CREATION DATE : 18-OCT-17
BID NUMBER: 7565537,1
TITLE: SECURITY DOOR UPGRADES AT SEVEN
LOCATIONS-MILITIA

October 18, 2017
ADDENDUM NUMBER ONE
RFQ # 7565537

TITLE: SECURITY DOOR UPGRADES AT SEVEN LOCATIONS-MILITIA
Closing Date and Time: 11/03/17 AT 2:00PM (Note Change)

REVISED STATEMENT OF WORK (10/19/17)

MORTISE LOCK, DOOR TYPICAL

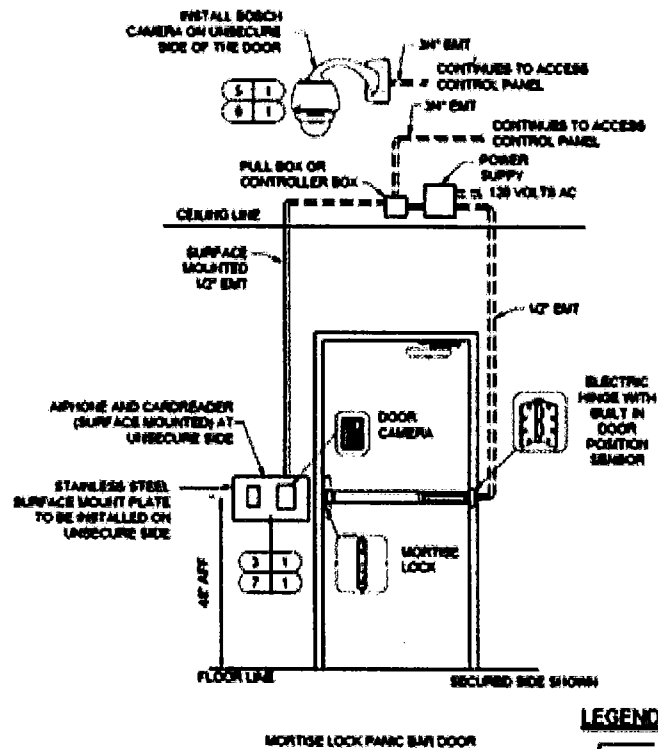
A. The scope of work is limited to the replacement of the doors and bringing in the AC power to a junction box above the doorway, and providing power to the door frame according to the manufacturer's instructions. (see typical diagrams)

The following typical diagram for a single, **Electronic Mortise Lock Door**
